Access Compliance Report

Public Rights-of-Way

(Curb Ramps)

Intersection ID: 12519	Main Street: E_6TH_ST	Cross Street: N_CALDWELL_ST	Location: E
ADA ID: 578346F68148	Ramp Type: Perp	Initial Pass/Fail: Fail	Overall Compliance: No
			Severity Score: 21.25

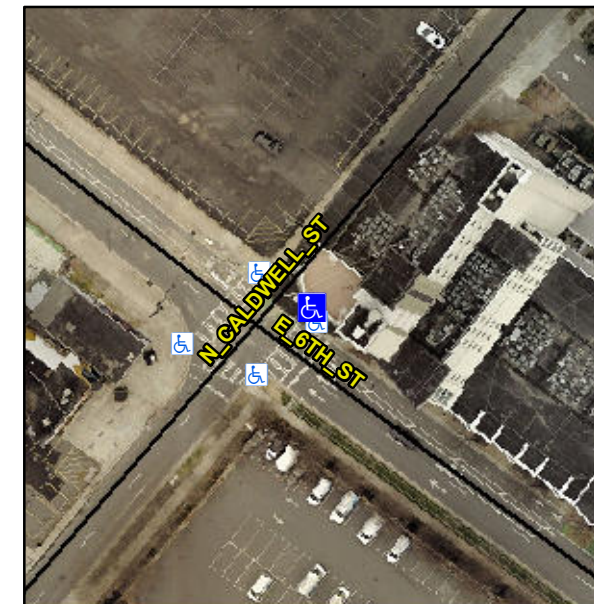
Not Found, R304.5.1, R304.2.2

Compliance	Description	Data	Compliance	Description	Data
N/A	Ramp Length (in)	70.0	No	Ramp Slope (%)	8.8
No	Ramp Width (in)	47.0	Yes	Ramp XSlope (%)	0.8
N/A	Flare Type LT	N/A	N/A	Flare Type RT	N/A
N/A	Flare Slope LT (%)	N/A	N/A	Flare Slope RT (%)	N/A
N/A	Flare Traversable LT?	N/A	N/A	Flare Traversable RT?	N/A
N/A	Landing Length (in)	N/A	N/A	DWS Provided?	N/A
N/A	Landing Width (in)	N/A	N/A	DWS Contrast?	N/A
N/A	Landing Slope (%)	N/A	N/A	DWS Length (in)	N/A
N/A	Landing X Slope (%)	N/A	N/A	DWS Full Width?	N/A
N/A	Landing Curb? (Y/N)	N/A	N/A	DWS Offset (in)	N/A
N/A	Shared Landing?	N/A			
N/A	Gutter Ponding?	N/A	N/A	Gutter Slope (%)	N/A
N/A	Gutter Lip Ht (in)	N/A	N/A	Gutter X Slope (%)	N/A
N/A	Painted X Walk1?	Yes	N/A	Painted X Walk2?	N/A
	X Walk 1 Direction	To NW		X Walk 2 Direction	N/A
N/A	X Walk 1 Width (in)	110.0	N/A	X Walk 2 Width (in)	N/A
	X Walk 1 Slope (%)	3.7		X Walk 2 Slope (%)	N/A
	X Walk 1 X Slope (%)	5.6		X Walk 2 X Slope (%)	N/A

Remove & Replace Entire Ramp.
